磁能灯泡

International application No.
PCT/CN2005/002257

INTERNATIONAL PRELIMINARY REPORT ON PATENTABILITY
(Chapter II of the Patent Cooperation Treaty)

WRITTEN OPINION OF THE INTERNATIONAL SEARCHING AUTHORITY

图 6

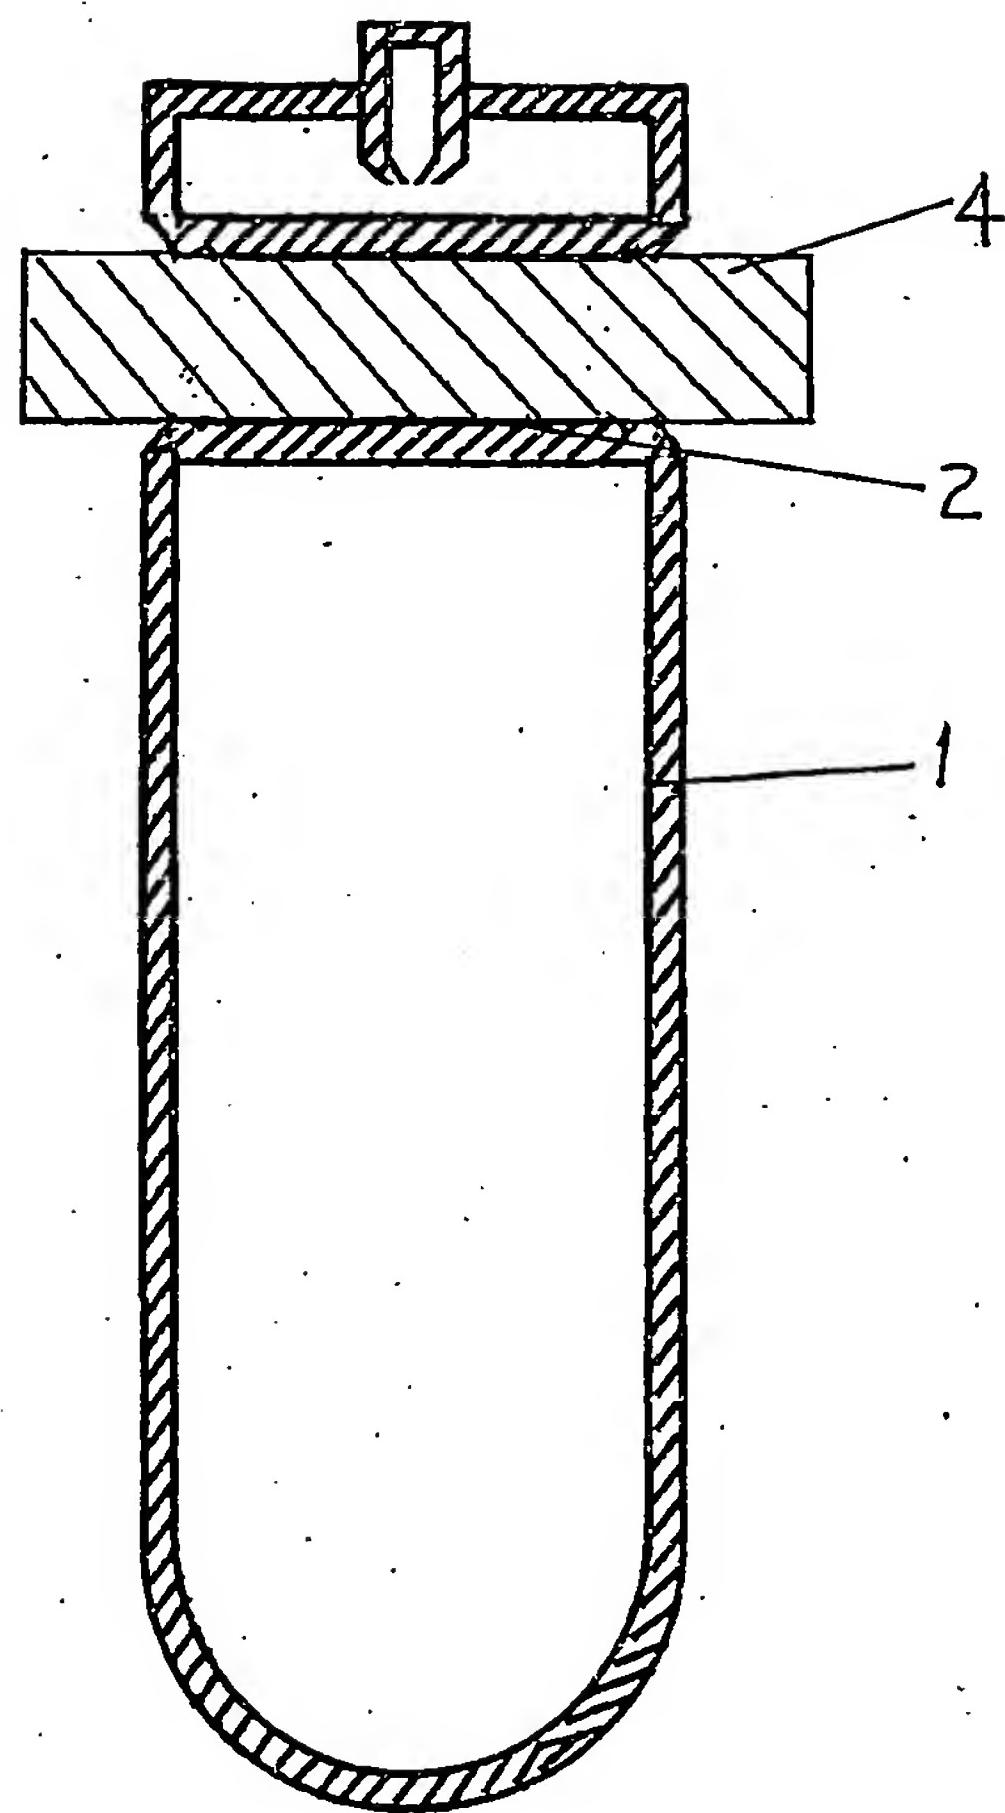
In the invention, instead of the conventional bulb with filament, the fluorescent power inside the magnetic energy bulb is activated by a magnetic body 4 through a through hole 2 on the lamp body to make the magnetic energy bulb illuminate and light, consequently to solve the technical problem of improvement in service life. But the essential technical feature "the magnetic body 4" for solving the technical problem is not mentioned in the claim 1, so the claim 1 is not complied with PCT Article 6.

本申请采用穿过灯体贯穿孔 2 的磁体 4（利用高频磁能电磁谐振原理）激活磁能灯内的荧光粉来使其发光照明以取代传统的带灯丝的灯泡，从而实现本申请解决的技术问题：提高使用寿命，但权利要求 1 没有提及解决技术问题的必要技术特征“磁体 4”，因此权利要求 1 不符合 PCT 第 6 条的规定。

本申请采用穿过灯体贯穿孔 2 的磁体 4（利用高频磁能电磁谐振原理）激活磁能灯内的荧光粉来使其发光照明以取代传统的带灯丝的灯泡，从而实现本申请解决的技术问题：提高使用寿命，但权利要求 1 没有提及解决技术问题的必要技术特征“磁体 4”，因此权利要求 1 不符合 PCT 第 6 条的规定。

In the invention, instead of the conventional bulb with filament, the fluorescent power inside the magnetic energy bulb is activated by a magnetic body 4 through a through hole 2 on the lamp body to make the magnetic energy bulb illuminate and light, consequently to solve the technical problem of improvement in service life. But the essential technical feature "the magnetic body 4" for solving the technical problem is not mentioned in the claim 1, so the claim 1 is not complied with PCT Article 6.
